#### REMARKS

The present amendment is made in response to the Office Action having a mailing date of March 28, 2000, which set a shortened three-month period for response, making this response due by June 28, 2000.

1 of 2

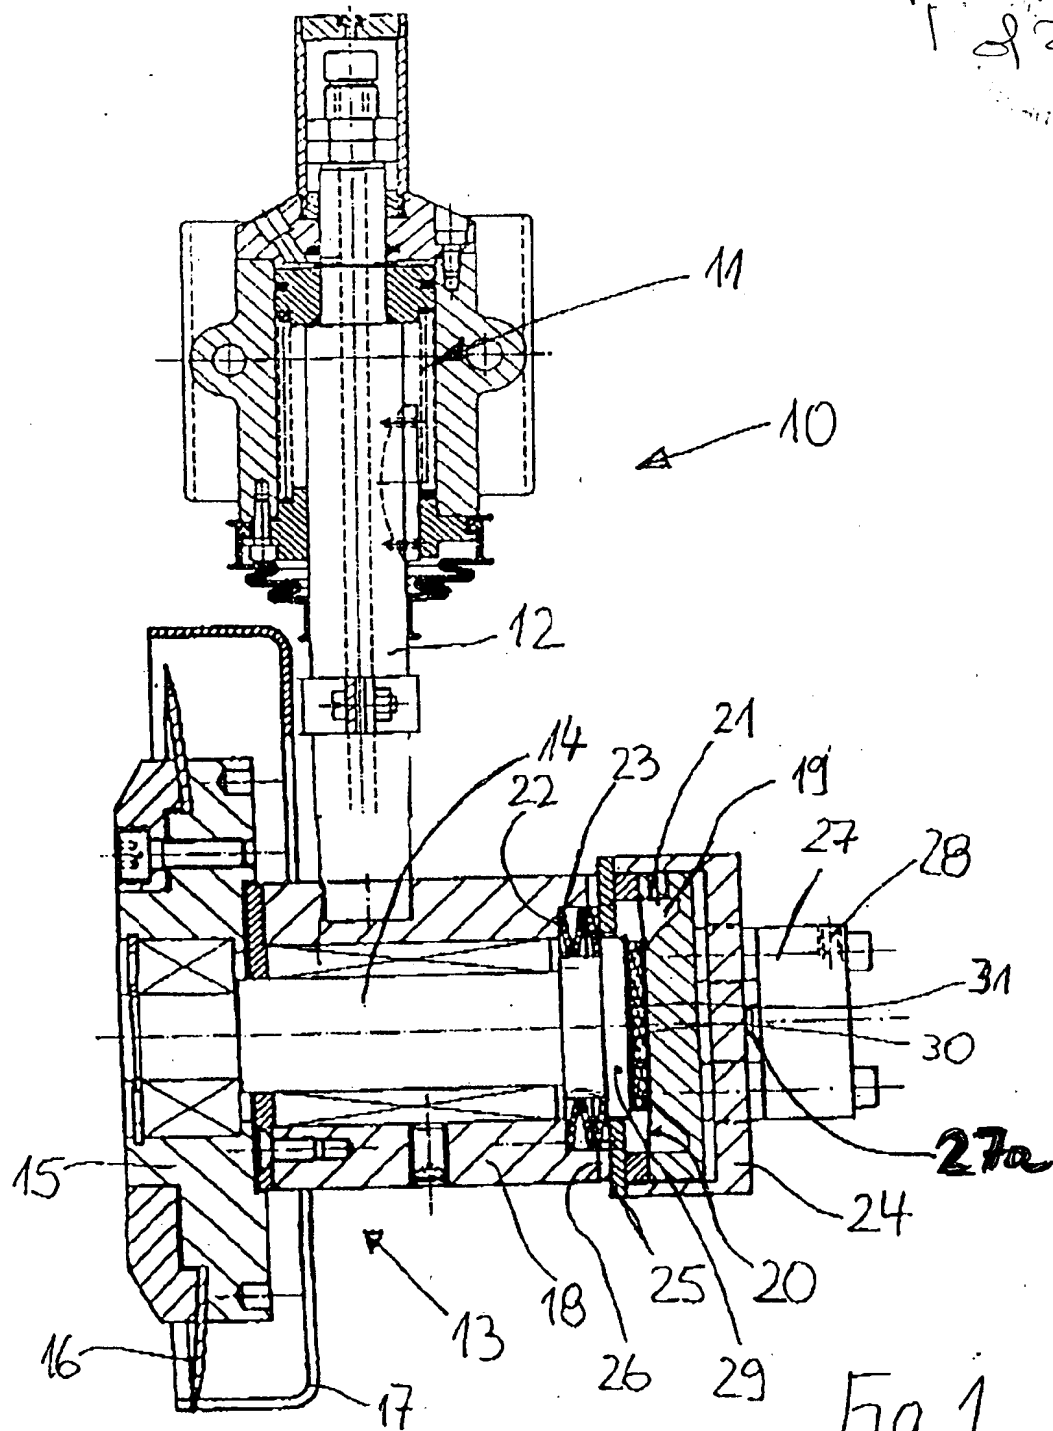
In the Office Action, the drawings were objected to for several informalities. Attached herewith are corrected Figures 1 and 2, with changes indicated in red ink,

which Applicant believes overcome these objections. More specifically, Figure 1 has been amended to include reference numeral 27a to indicate the portion of the piston in the space between 27 and 24. The specification has likewise been amended on page 9, at lines 6 and 9, to more clearly describe the preferred configuration on the pneumatic drive 27, as shown in Figure 1, with reference to 27a. Because these structures have already been disclosed in Figure 1, this amendment to the specification does not comprise new matter.

Fig. 2

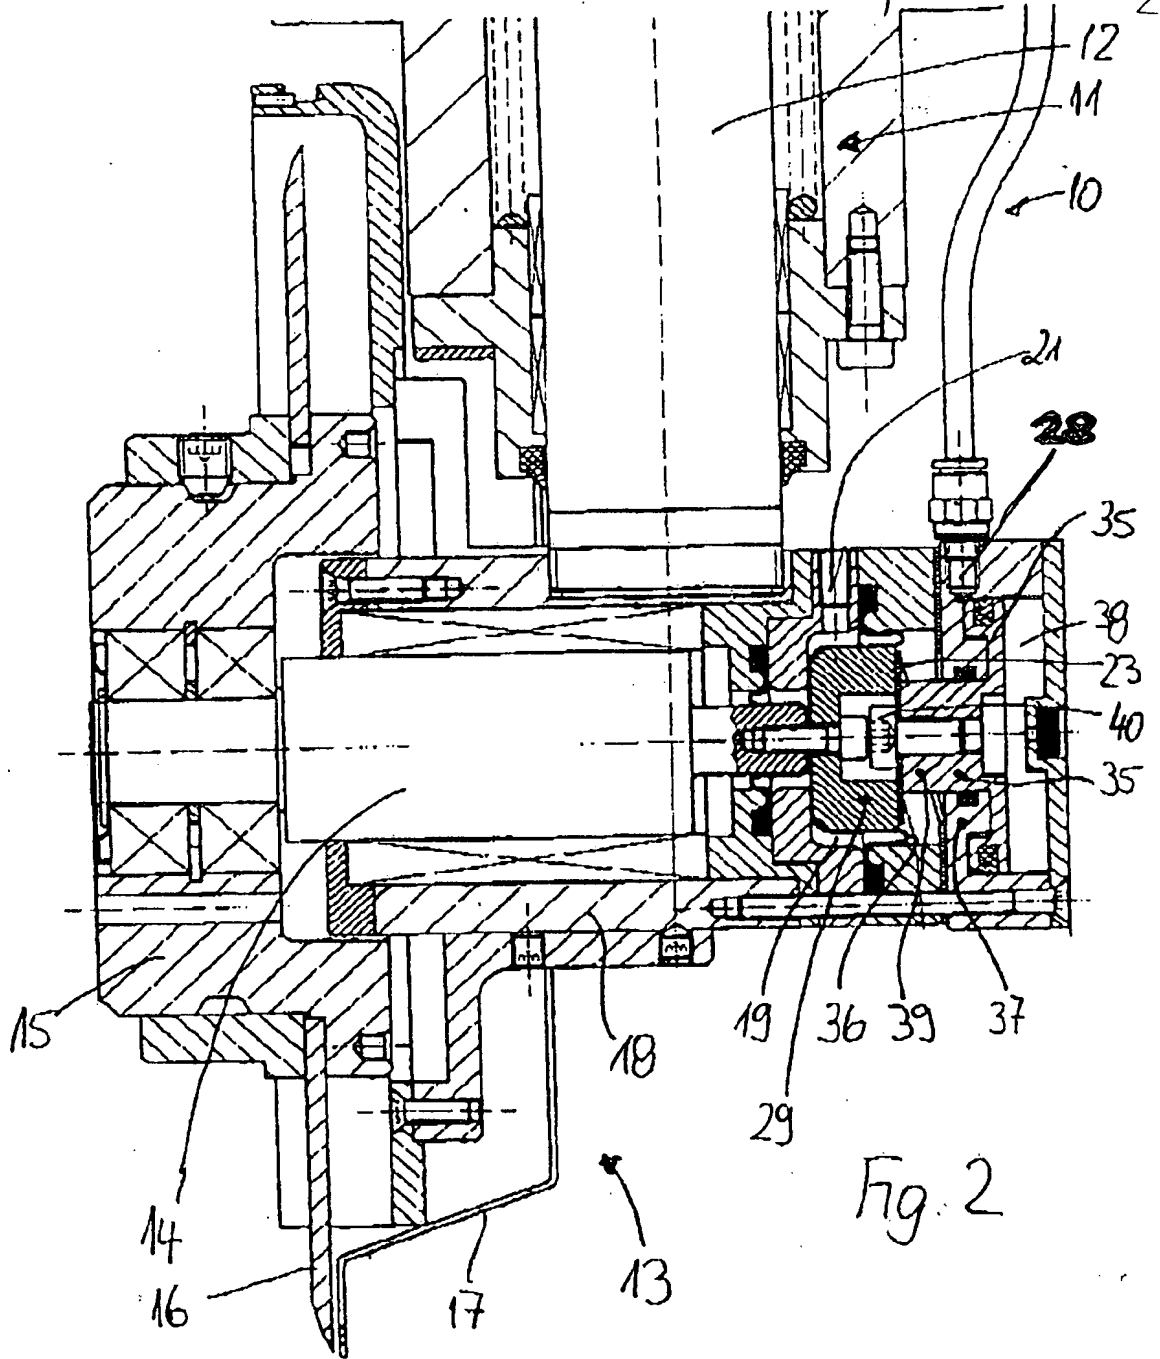
With regard to the objection to Figure 2, Figure 2 has been amended to correctly indicate pneumatic connector 28, which had been incorrectly labeled as pneumatic drive 27. In the embodiment shown in Figure 2, the pneumatic drive for the piston 35 is designed so that via the pneumatic connector 28, the compressed air is introduced between the partition wall 37 and the piston 35, thereby causing the movement of the piston 35. In this regard, the specification was necessarily amended on page 12, at lines 8 and 9, to more clearly and correctly describe the function of the pneumatic connector 28 and its action upon the piston 35. Again, because Figure 2 already disclosed this element, but was merely mislabeled, this amendment to the specification does not comprise new matter.
